Re: Regional and Provincial Comments-Proposed Official Plan Amendment, Zoning By-law
Amendment Applications
City Files: OPA 33: Zoning File: 2020-14
Applicant: Lucas Lucchetta and Lucchetta builders Inc.
Agent: Joseph Tomaino
368 Aqueduct Street and 155 Gadsby Avenue City of Welland
Environmental Consultant: 8Trees Inc.

Technical Response to Memo dated Nov 18, 2022

Figure 2. Recommendations for woodland enhancement and improved ecological and social functions. Areas beyond the current property limits are suggestions only, to protect and enhance the overall woodland.

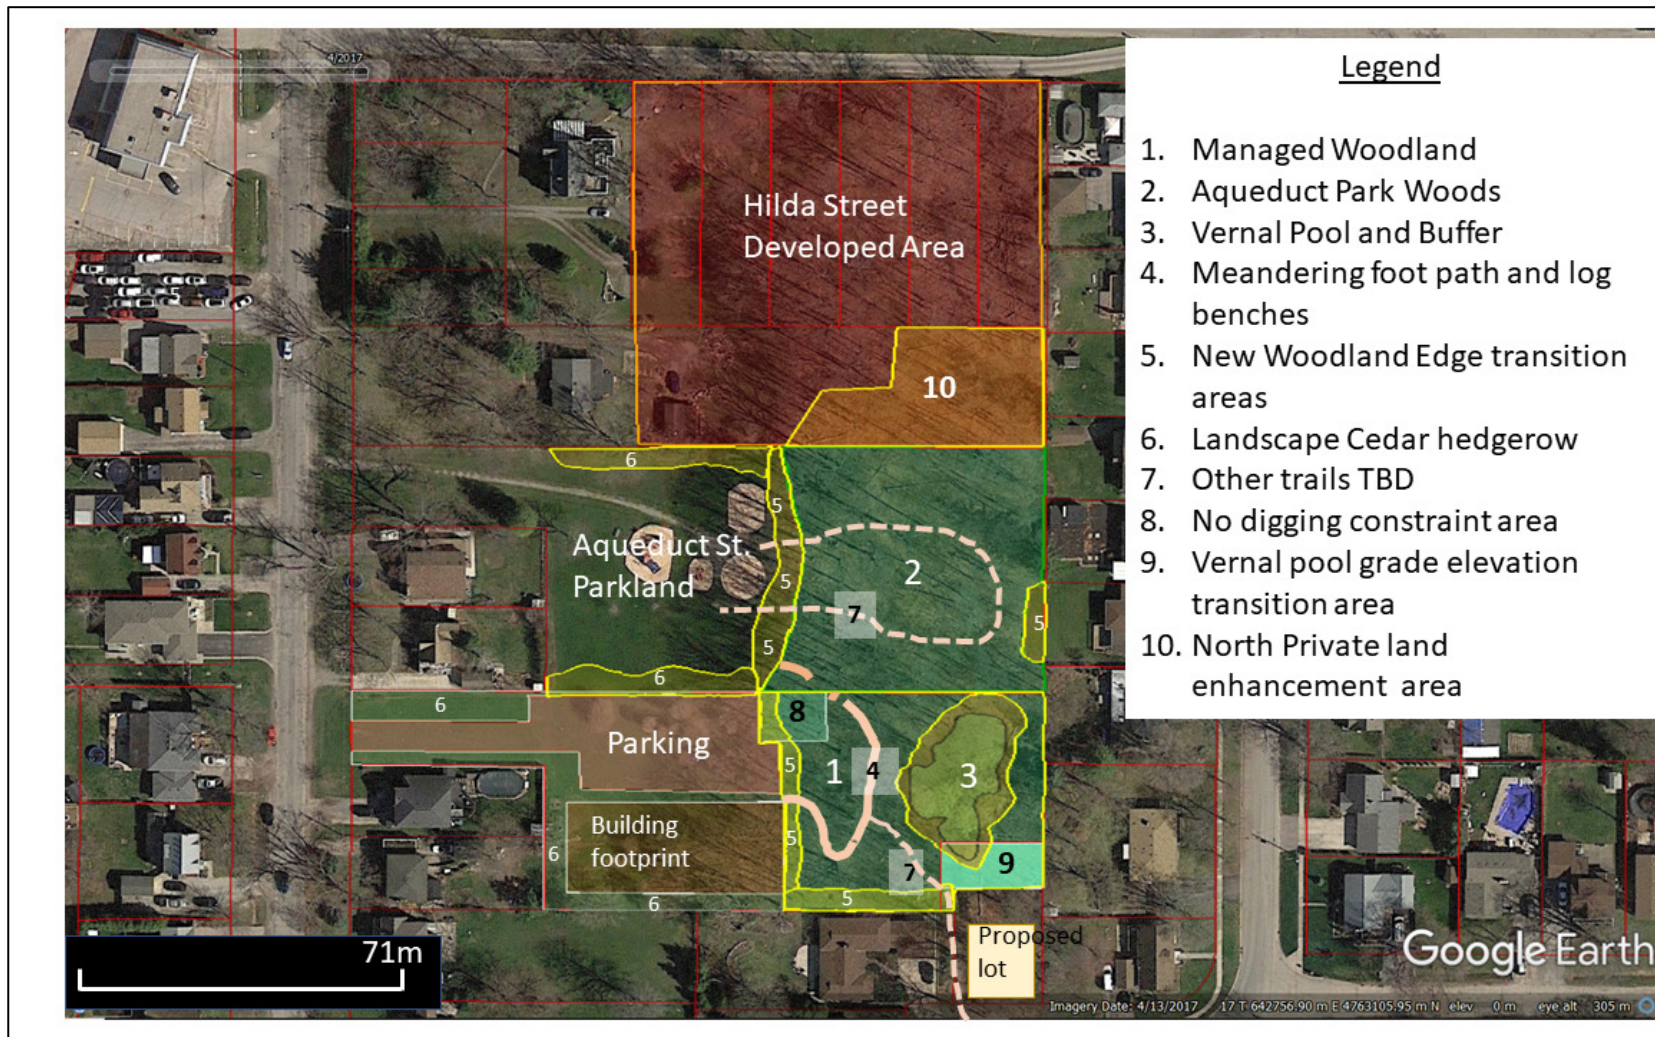
- The woodland management plan is ecologically feasible, discussion with City staff will follow acceptance of the plan in principle. See attached Fig. 2 and Table 2 to see where enhancement opportunities exist.

- Management actions within the remaining woodland include the control and removal of invasives and poison ivy, removing waste and garbage, adding habitat features (nesting, cover, roosting), planting trees, and restoring the understory plant diversity. This is a gain in habitat quality and diversity of 2700m². A preliminary concept was laid out in the Woodland Management Plan (8Trees letter dated July 2022). See attached Table 2 and Fig. 2 for further details on enhancement opportunities.

DRAWN BY: J.P. DATE: 2023-01-23
 9:37:06 AM
 SCALE: As indicated JOB #: Project Number
 SHEET NO: **SP-1 B**

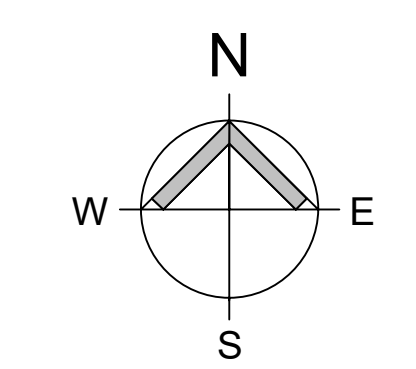
RMON Comment Page 4: Differences between Site Plan and Woodland Management Plan

- Please see an attached revision to the site plan drawing to show the woodland path that matches the proposed woodland management plan.
- Following the application of the tree preservation and planting and ecological restoration work, an EC zone may be appropriate for the remaining woodland. This is to be determined by the planning authority.
